VOLCANO TRAILS

Sector Development Plan

~~July 2010 Draft~~
March 2011 Red-line

Note for EPC Hearing March 3, 2011:

Exhibit 4, Volcano Trails Plan Location

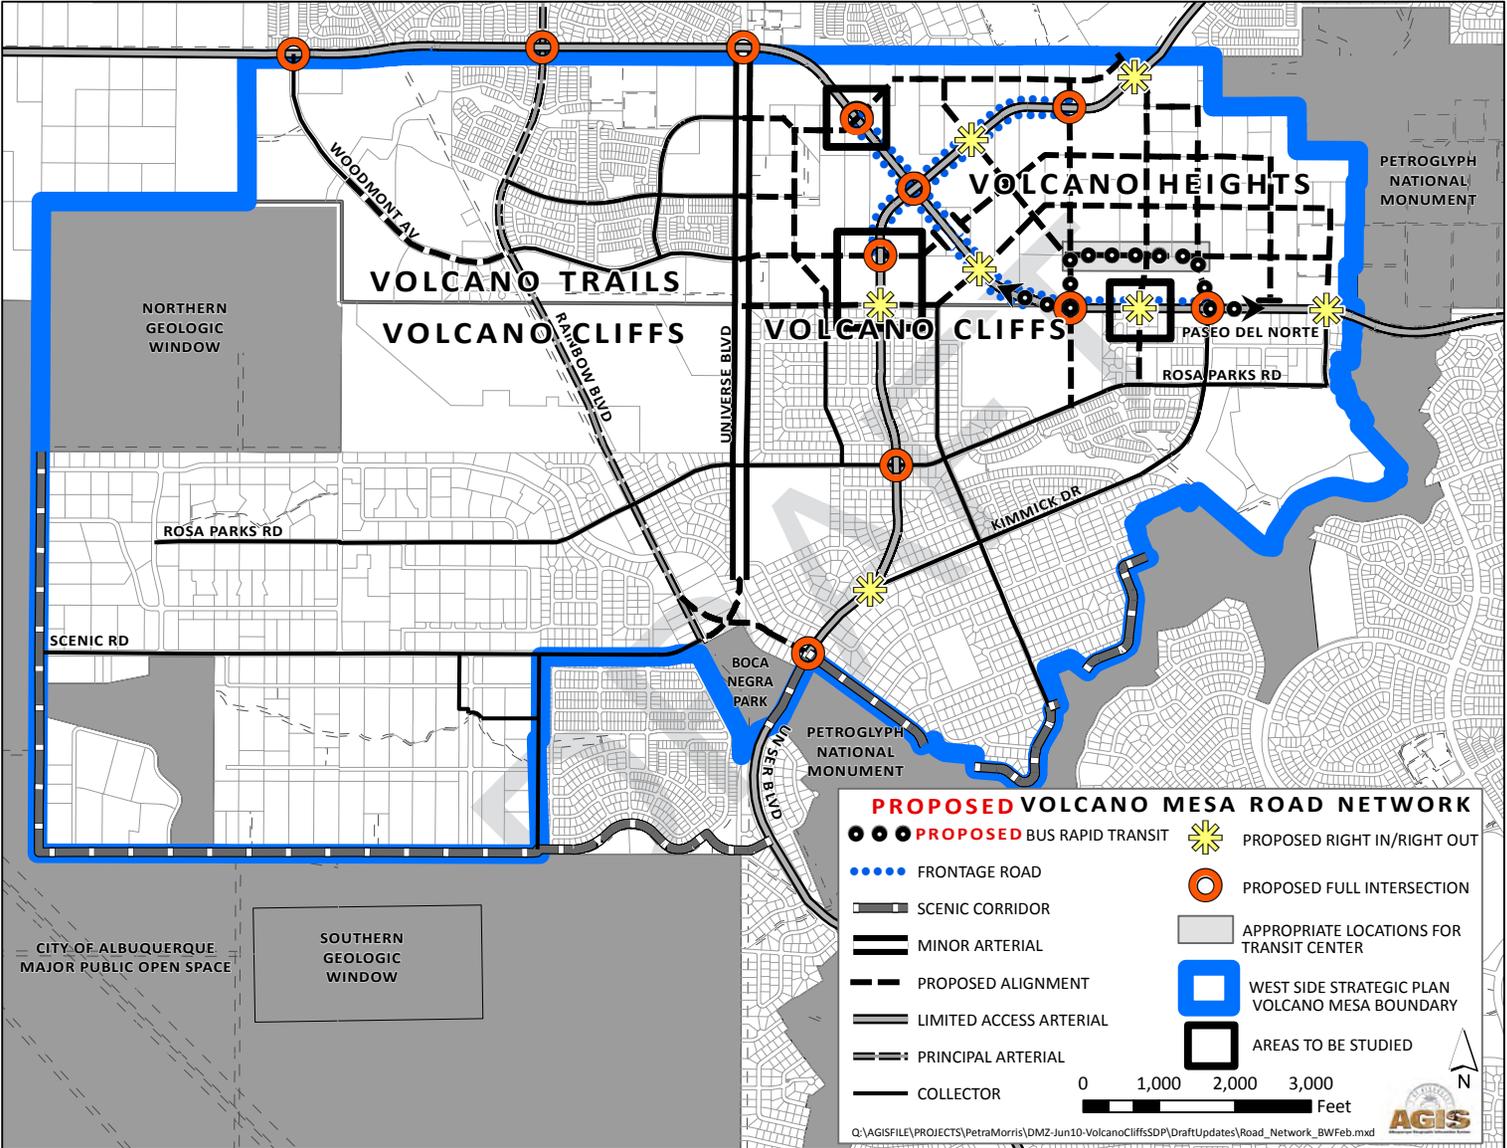
[Graphic to come showing boundaries mentioned in “Area overview.”]

Exhibit 6-5, Volcano Trails Road Network

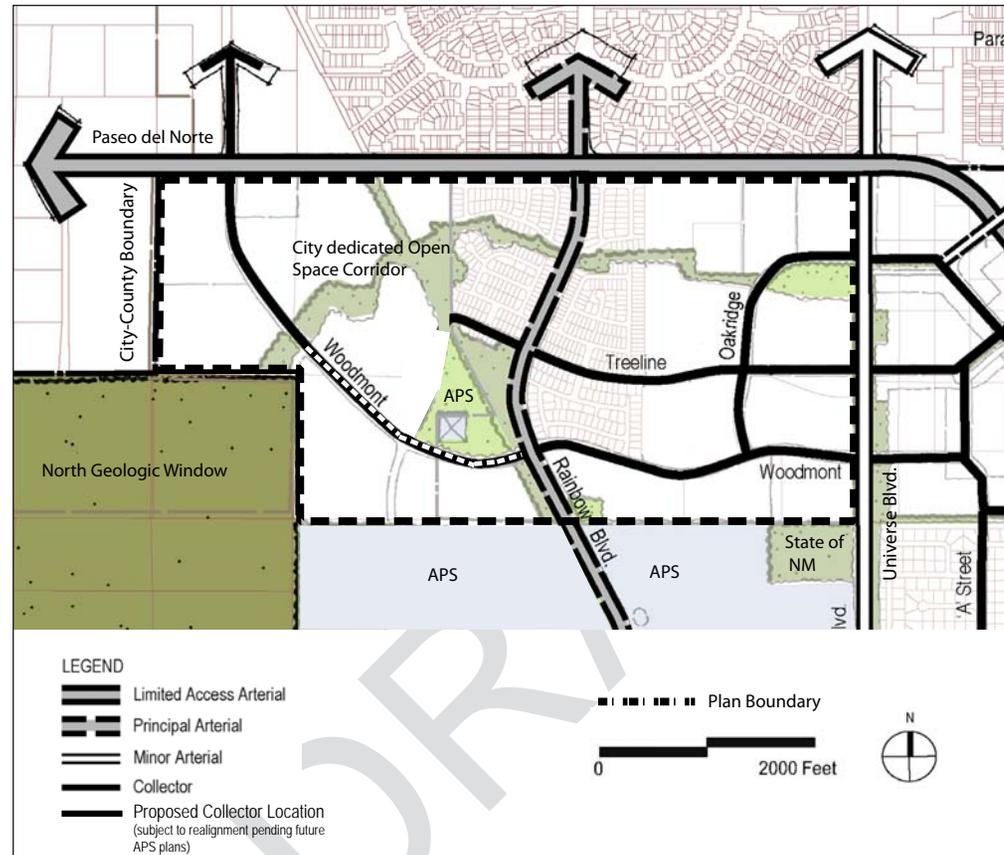
[Graphic to be revised to change base map and remove open space, APS, and State of NM lands"] [320]

Exhibit 10-7, Zoning and Land Use Plan Established by the Volcano Trails Sector Development Plan

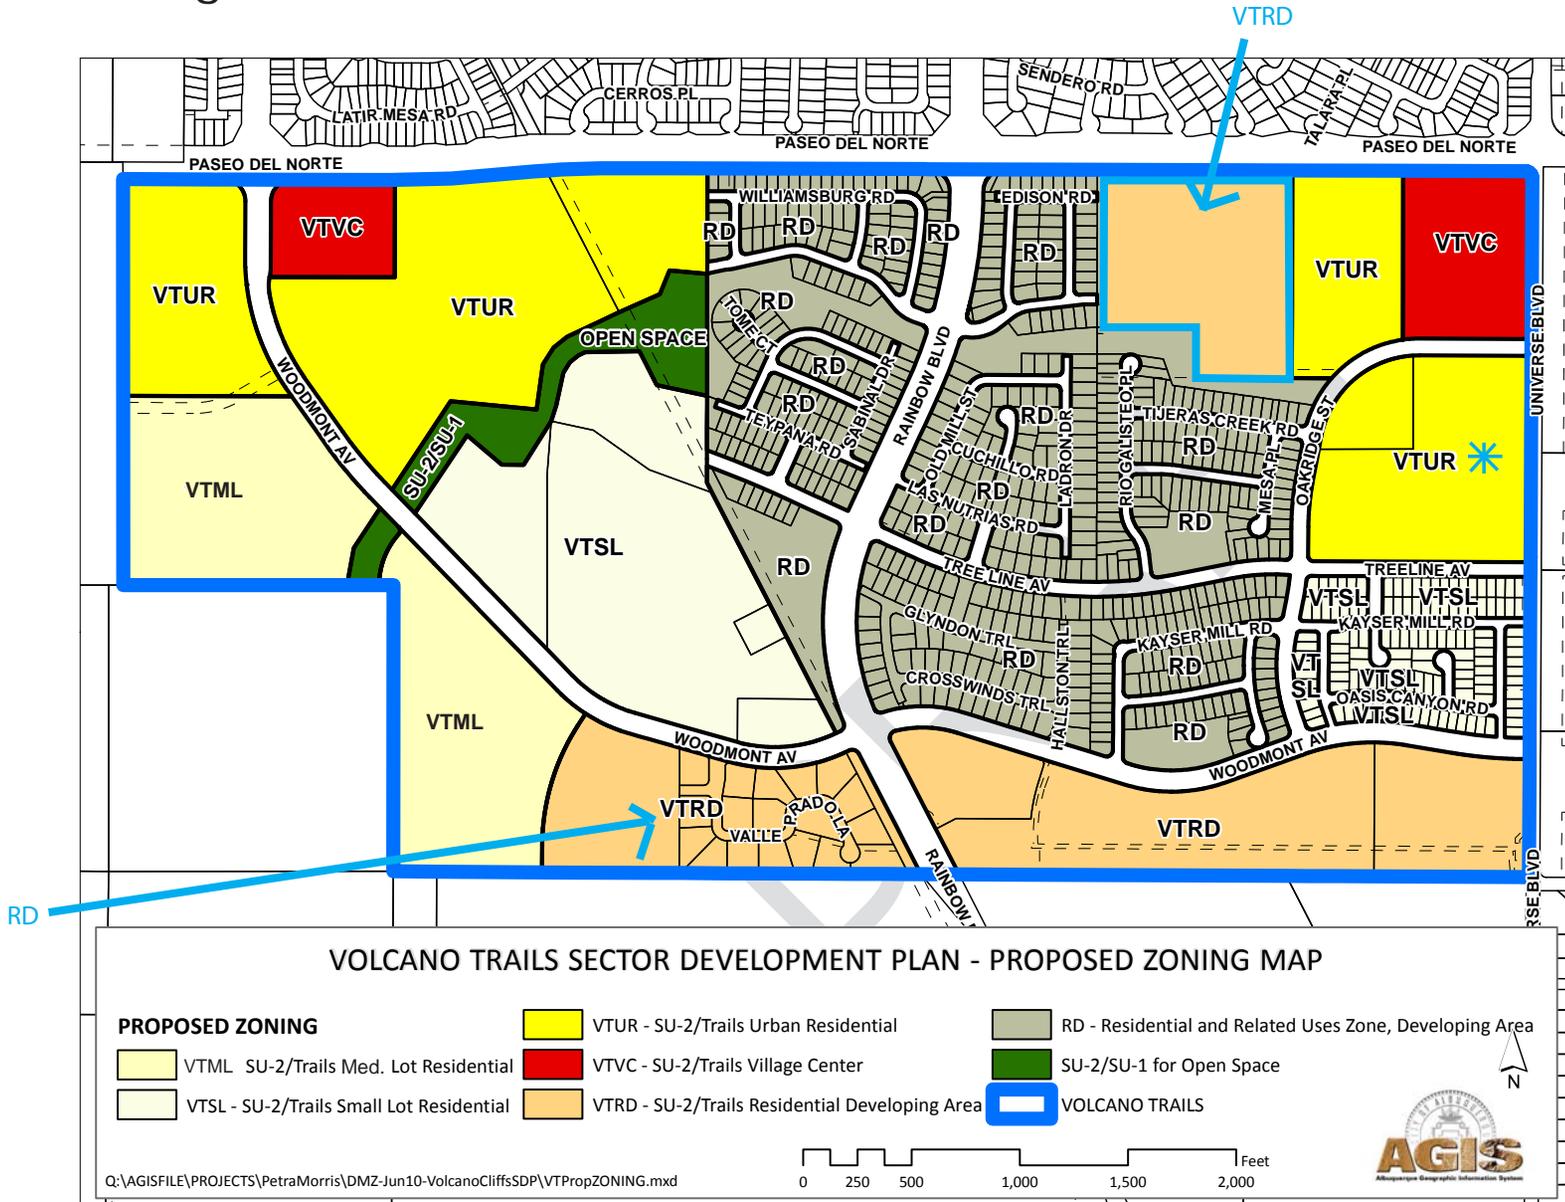
[Revise graphic: delete “proposed” from title, replace “SU-2/SU-1 for Open Space” with “SU-2 Volcano Trails Open Space”, insert “SU-2” before “RD - Residential and Related Uses Zone, Developing Area” in the legend, replace VTRD zoning with RD in Unit 2, Tract 8 (currently the VTRD tract west of Rainbow, add an asterisk to VTUR south and east of Oakridge, show 200’ and 500’ buffers from escarpment on VTML, show unplatted RD in Unit 2, Tract 1 as VTRD.]

[332]

[333]

[368]

BUILDING PLACEMENT DIAGRAM

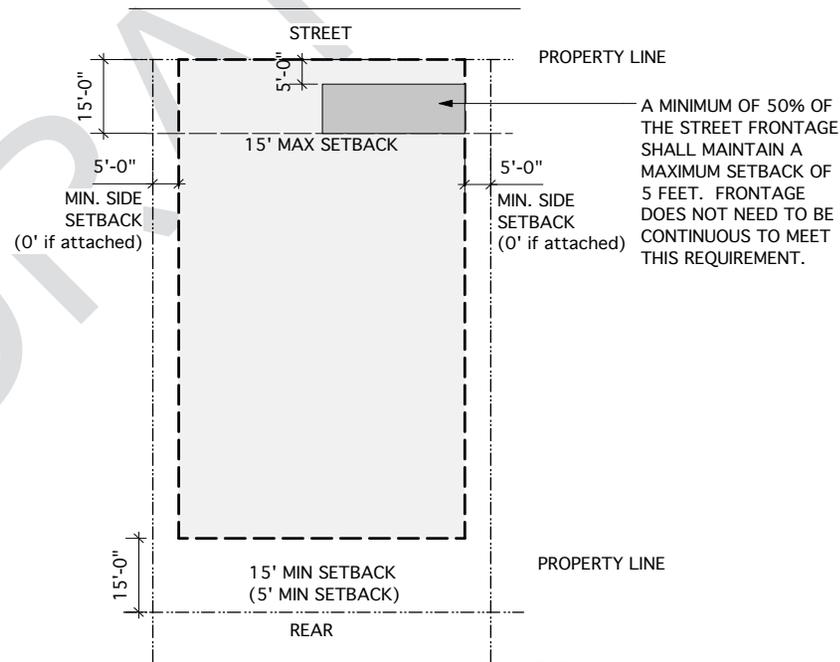
[NOTE: Diagram to be revised to add hatching. 354]

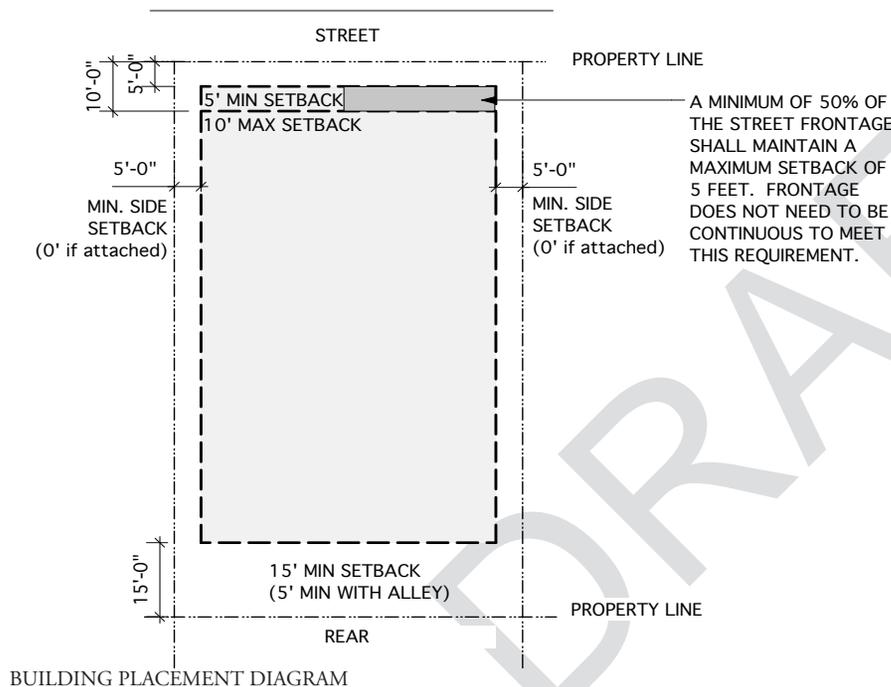
[NOTE: Diagram to be revised to add hatching. 354]
